# DAMMON ENGINEERING, INC.

November 16, 2011

REF: Roof Curb Calculations  
PNK Support Facility  
Baton Rouge, LA

Dammon Engineering was contacted to verify adequate structural support for various roof mounted equipment for the above referenced project.

SHEET NO. **FA1.00**

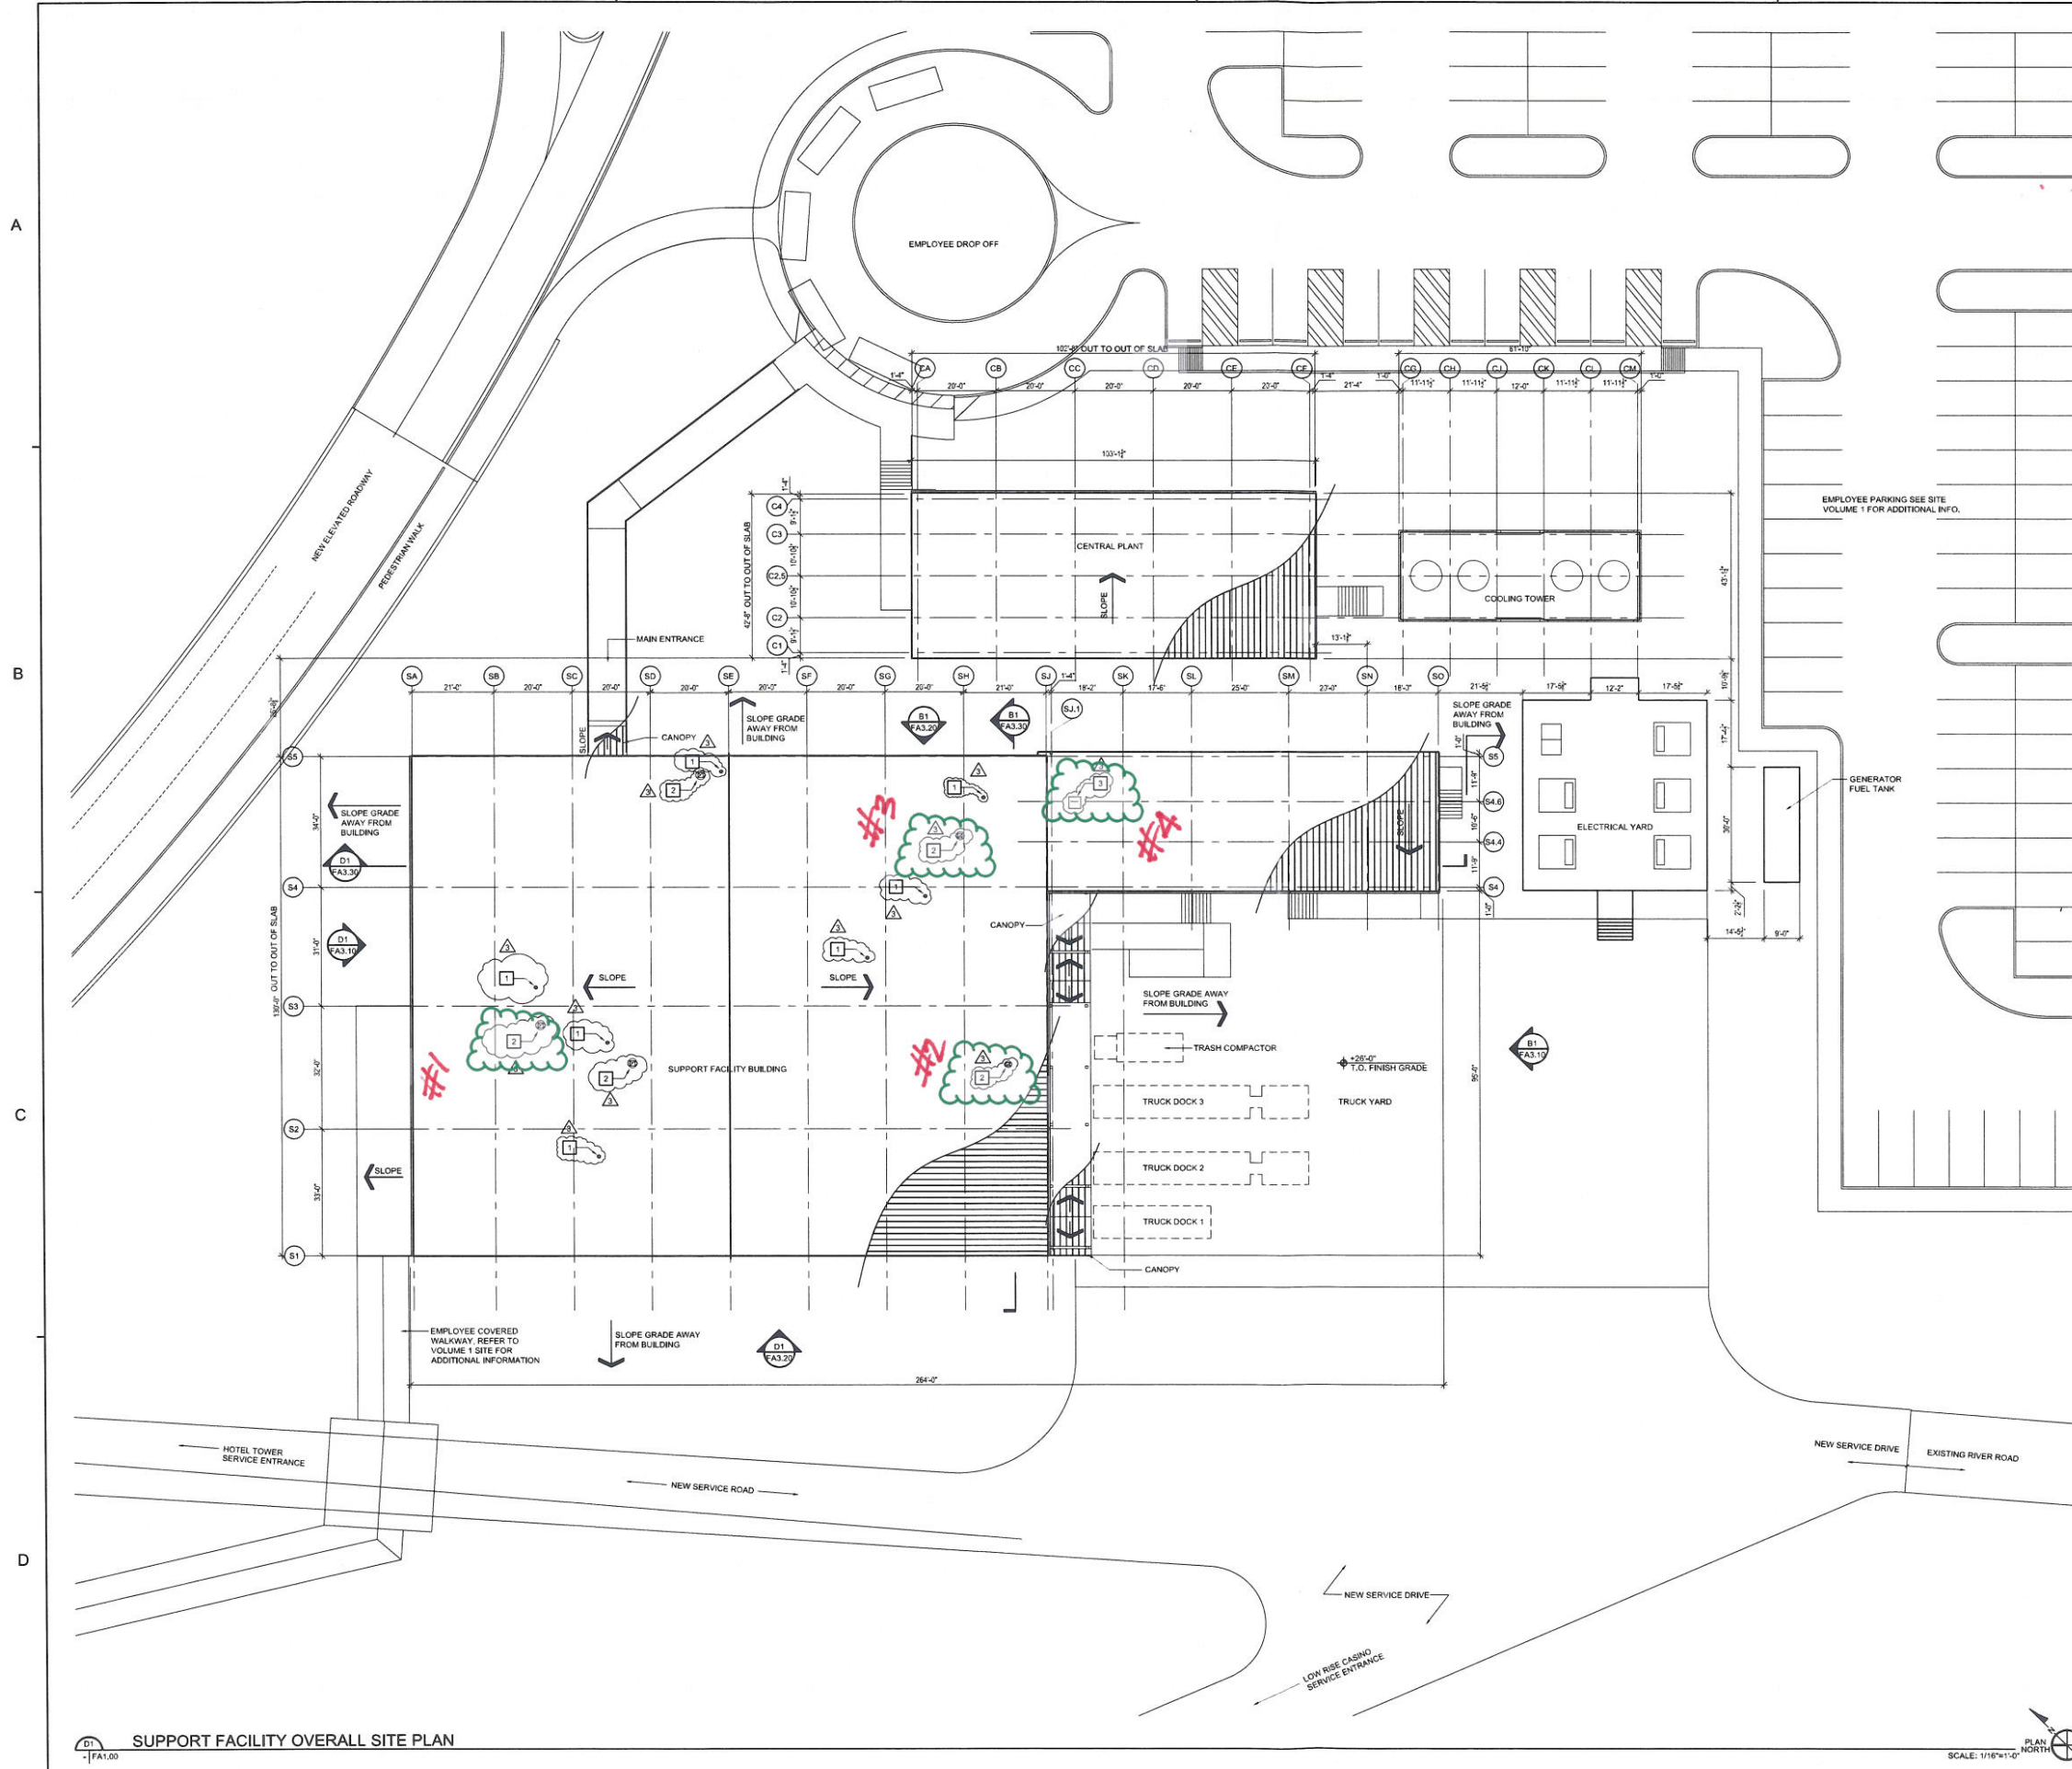
- Roof curb bearing on a minimum of 2 Horizontal Z-shape (Z8.50x0.105) roof purlins
- Maximum Deflection of Purlins =  $L/360$
- Placement of Roof Curbs as shown on Sheet FA1.00 (attached)

The proposed Roof curb Supports are approved as shown in the attached calculations. Install all framing and roof curb components per manufacturer requirements to provide a complete curb system.
